Subject: Request for Additional Information (RAI) Responses Pertaining to Nuclear Criticality Safety and Management Measures (Chapters 5 and 11, respectively, of License No. SNM-1227 Renewal Application)

RAI RESPONSES – AREVA NP RICHLAND (SNM-1227), October 3, 2008

Chapter 5: Nuclear Criticality Safety

The above figure shows the Drum Storage Racks; Base Case; $4 \text{ g/cm}^3 \text{ UO}_2$ with 0.5, (limit of moisture content specified in the NCSS) 1.0, and 2.0 wt% H_2O ; IM Varied between Dry and Fully Flooded

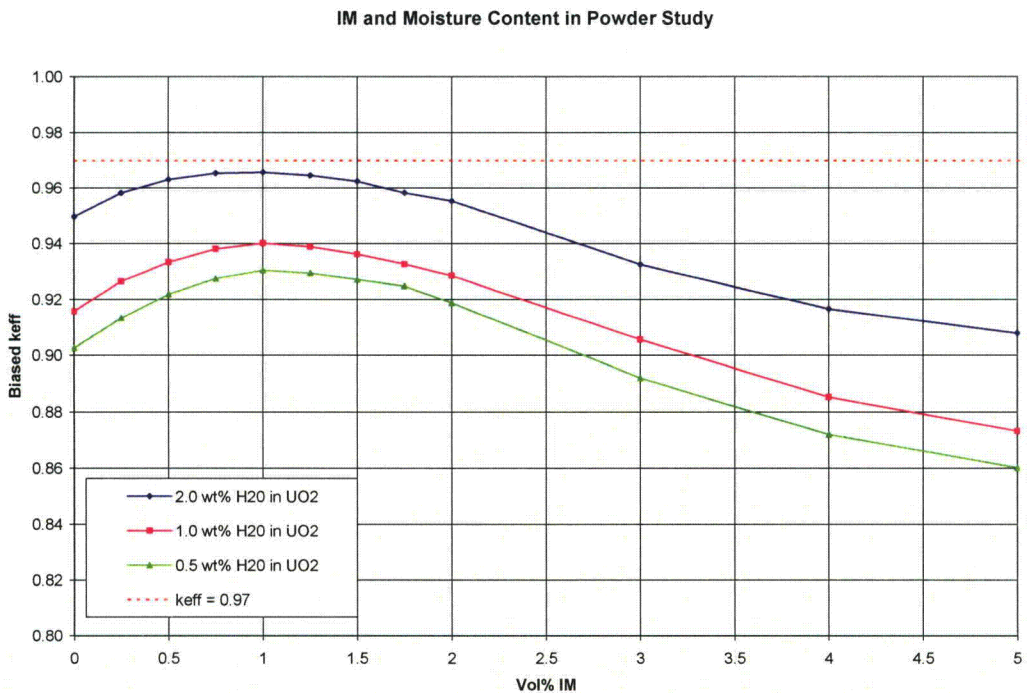
- i. Does the requirement to perform a sensitivity analysis apply only to credible abnormal conditions, or to both normal and credible abnormal conditions?
- ii. Provide illustrative examples of such a sensitivity analysis. Explain how they justify the use of the stated $k_{95/95}$ limits.

Two examples are provided that show sensitivity studies supporting the 0.97 and 0.95 limits. The first example deals with dry powder storage in the BLEU powder storage area. The NCS limit on powder moisture content is 0.5 wt% moisture in the powder. The point that the moisture control IROFS would be declared as failed is if the moisture content exceeds 2

wt%. The following graph shows the significant margin in k_{eff} between these two concentrations and the gradual change in k_{eff} over the full range of moderator interspersed between the drums of powder.
